PLANT NAME: Nine Mile Pt. Unit 1

Re: Niagara Mohawk Power Corporation
Nine Mile Point Nuclear Station
Unit No. 1
Docket No. 50-220

AMENDMENT TO APPLICATION FOR AMENDMENT
TO
TECHNICAL SPECIFICATIONS

Proposed Change to Technical Specifications

FIGURE 3.1.7b MAXIMUM ALLOWABLE AVERAGE PLANAR LHGR
APPLICABLE TO FUEL TYPE 2 - RELOAD 1

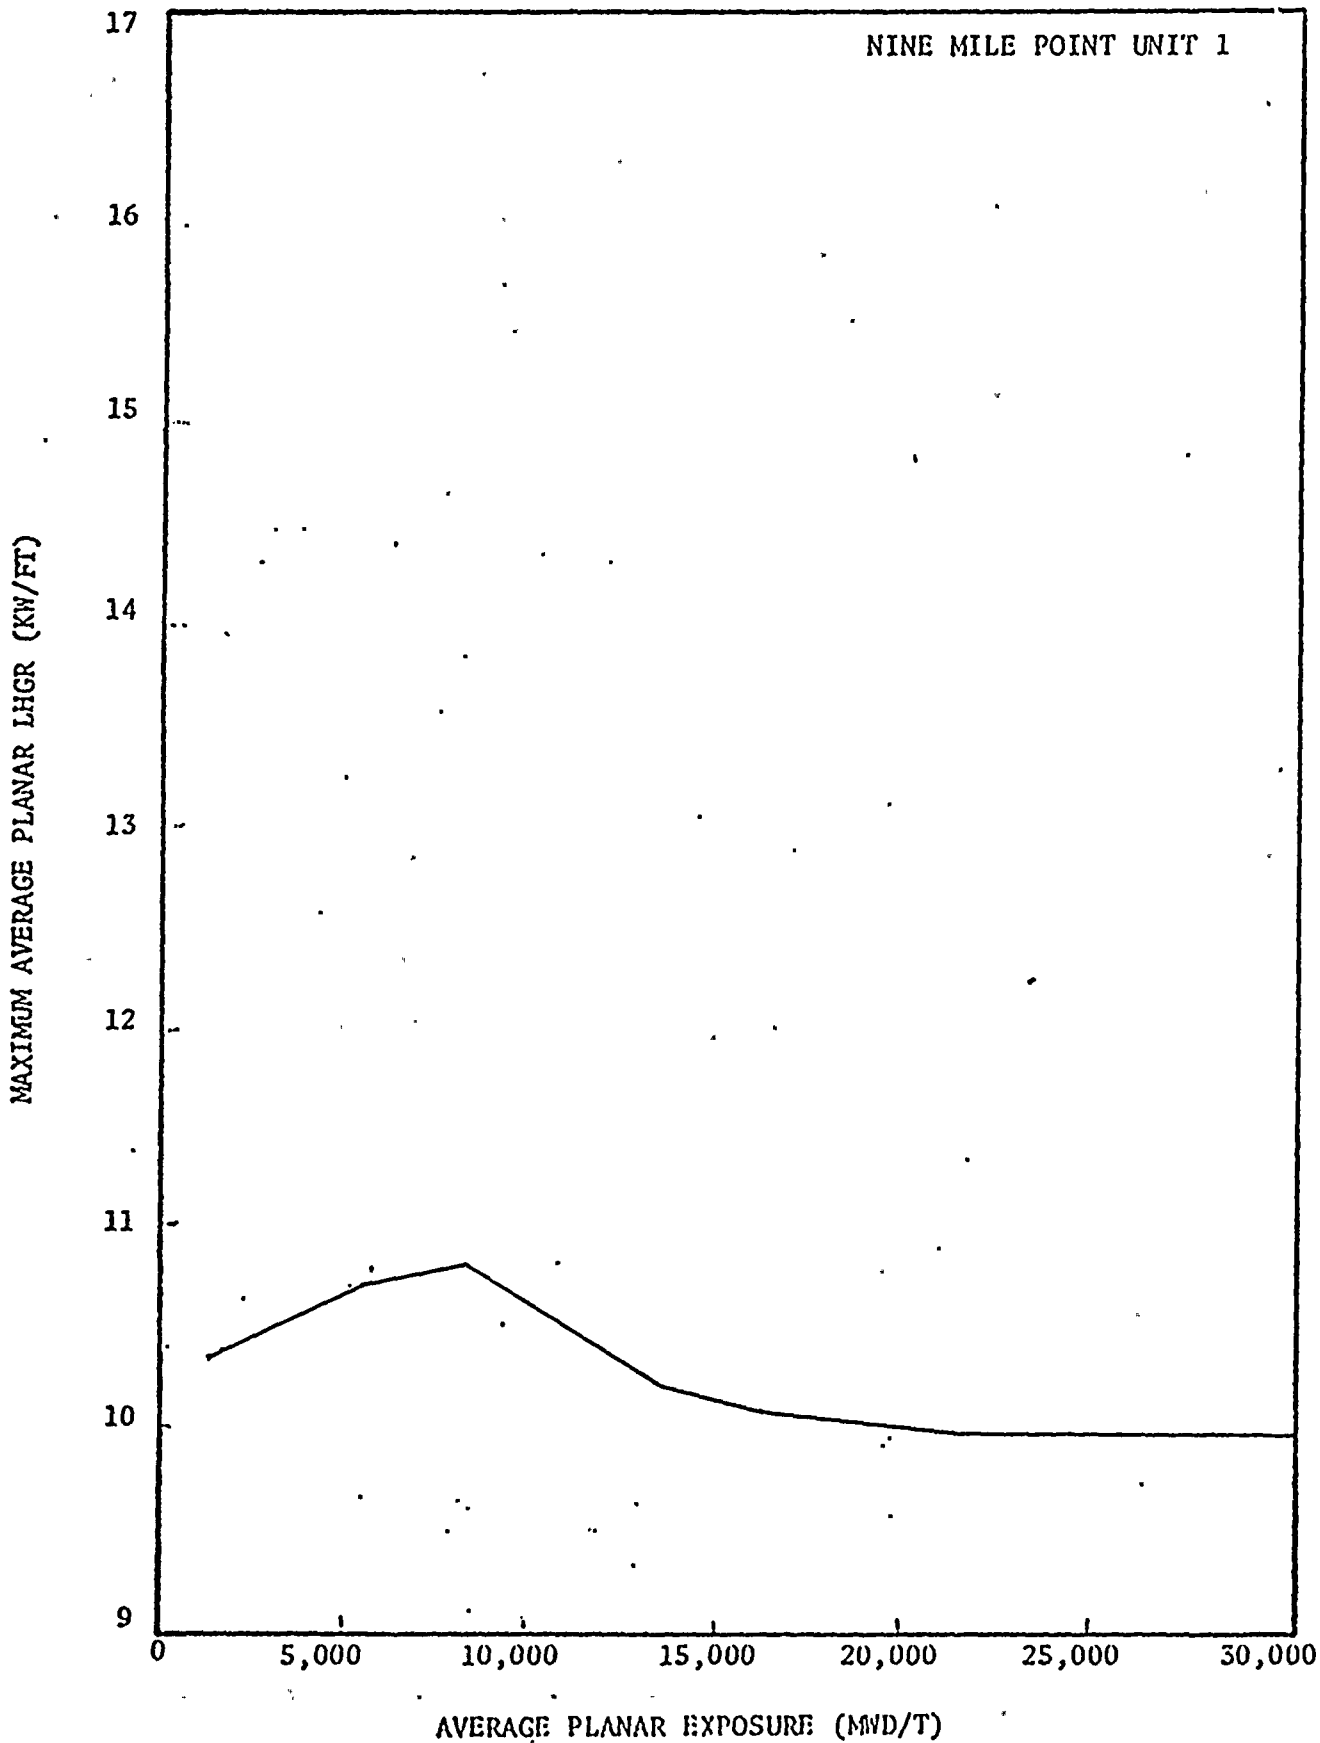
<u>Item</u>	<u>Location</u>	<u>Change</u>
Limiting Condition for Operation 3.1.7a	Pages 66 and 68	Replace Figures 3.1.7b and d with the attached Figures 3.1.7b and d.

The information transmitted in this document supplements the loss of coolant accident analysis submitted on October 31, 1975. The revised curves and tables presented in this attachment and Attachment C replace similar information previously noted as preliminary. In addition, Figures 3.1.7b and d of Attachment A of the October 31, 1975 submittal have been revised.
